## COUNCIL ASSESSMENT PANEL MEETING

### AGENDA – 8.1

<b>Applicant:</b> Sasha & Gary Holland	<b>Landowner:</b> S J L & G L Holland
<b>Agent:</b> Philip Harnett (URPS)	<b>Originating Officer:</b> Damon Huntley
<b>Development Application:</b>	20/1198/473
<b>Application Description:</b> Two storey detached dwelling, deck (maximum height 4.12m), combined fence & retaining walls (maximum height 3.4m), swimming pool & associated barriers, masonry fence, associated earthworks & landscaping	
<b>Subject Land:</b> Lot:50 Sec: P2797 DP:111446 CT:6175/564	<b>General Location:</b> 9 Braemar Terrace Stirling  <b>Attachment – Locality Plan</b>
<b>Development Plan Consolidated :</b> 08 August 2019 <b>Map</b> AdHi/28 & AdHi/72	<b>Zone/Policy Area:</b> Country Living Zone - Country Living (Stirling And Aldgate) Policy Area
<b>Form of Development:</b> Merit	<b>Site Area:</b> 771 m <sup>2</sup>
<b>Public Notice Category:</b> Category 2 Merit	<b>Representations Received:</b> 6  <b>Representations to be Heard:</b> 4

The purpose of this application is to construct a two-storey detached dwelling, deck (maximum height 4.12m), combined fence & retaining walls (maximum height 3.4m), swimming pool & associa

**Image 1: Difference in ground levels adjacent rear boundary.**

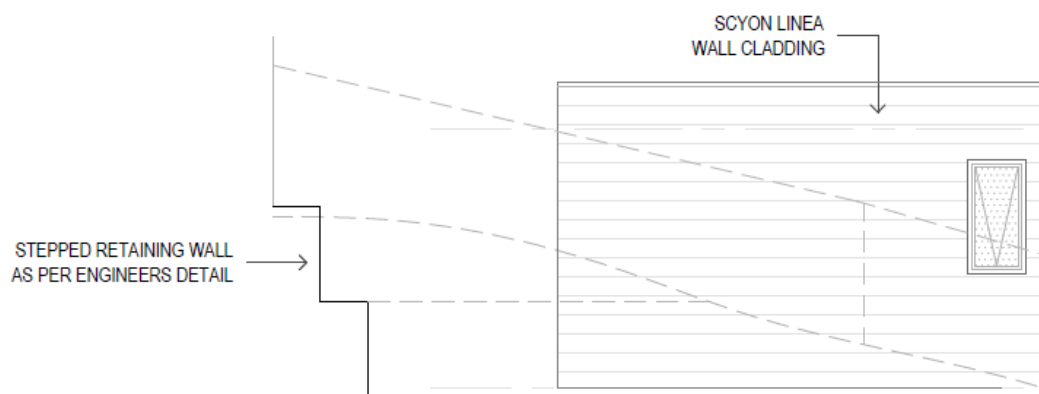
unreasonable amenity impacts upon this property (i.e. visual impact, overshadowing and privacy).

- The proposed side setbacks will not unreasonably diminish the open character of the locality, or the ability to provide reasonable landscaping across the site.

For all these reasons, the proposed boundary setbacks do not diminish the character of the locality or neighbouring amenity and are therefore acceptable despite shortfalls with respect to the numeric setback guidelines.

SITE PLAN - UPPER  
SCALE 1:200

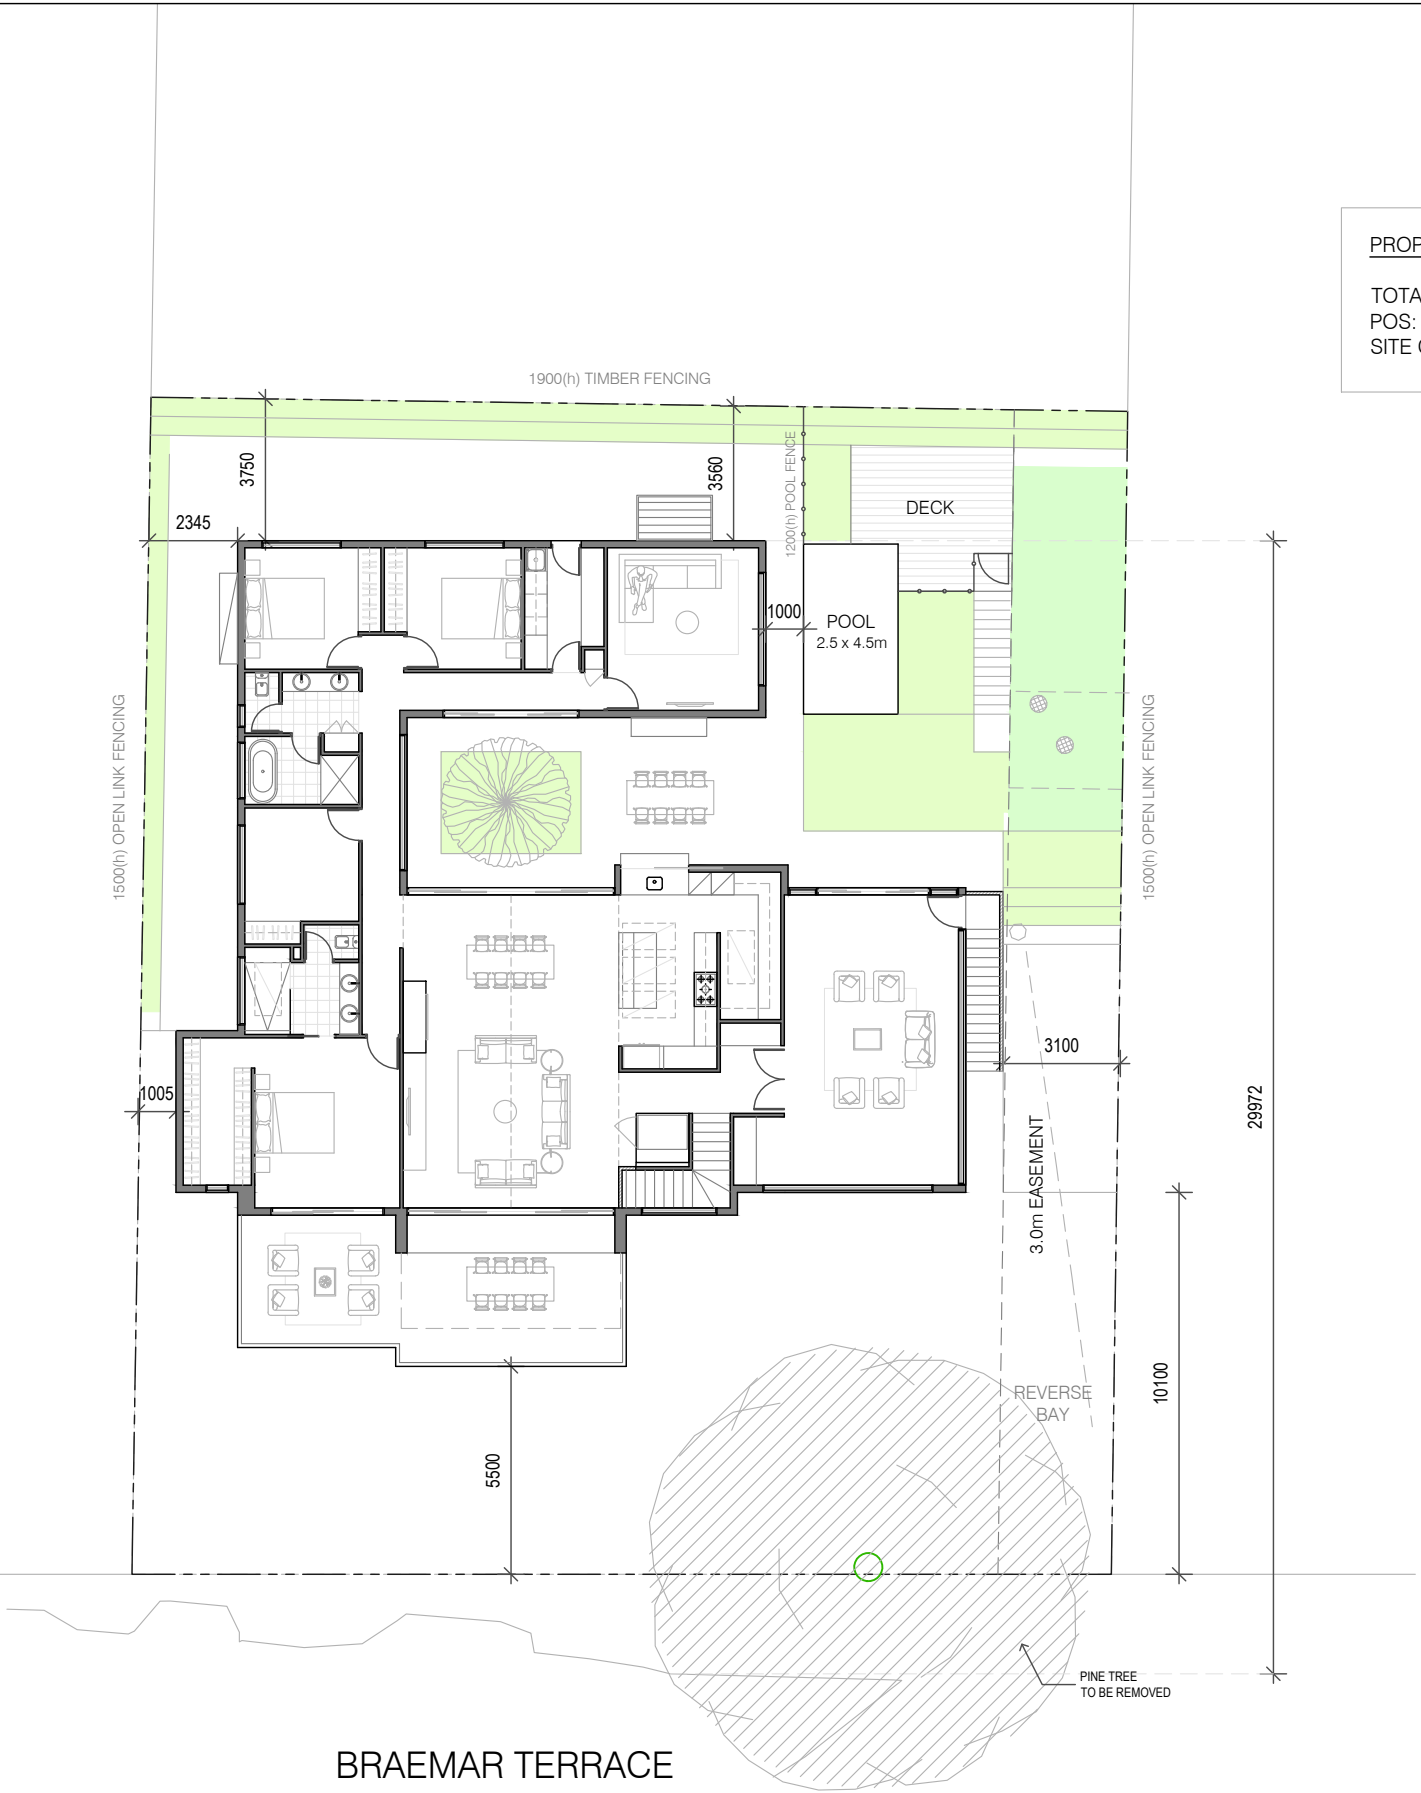
Site coverage is inaccurately stated and represented in the plans.

Based on the plans asserting on p. 3 that "Site Coverage" uses only "16 percent" of the lot, it appears this figure acknowledges a total of three rooms, all on the lower level: the Home Office, the Cellar/Theatre; and the Garage. The water tank storage area on the lower level and adjacent to the Home Office is actual site coverage, but not included in the “16%”.

Data on site coverage in the plans is thus incomplete and misleading.

(d) Private Outdoor Space/POS: Data and category are confusing in the plans. On pp.2, 3 POS is given as 283 m<sup>2</sup> (35%), also calculated on the erroneous 800 m<sup>2</sup> lot size, and specified as including the balcony and rear. More specific data and layout for POS is not included in the plans. Developers' letter (c) specifies front balcony as "useable outside area", but it is also part of "site coverage" as matching space above ground-level terrace. POS appears to be sufficient but dimensions are not provided for accurate evaluation. It is not clear whether differing use categories overlap and how that could affect coverage measurements.

The coverage of the dwelling across the land is 347.66 square metres which presents a site coverage of 45 percent. This satisfies the Development Plan.

The proposed site coverage is therefore appropriate with respect to the Development Plan.
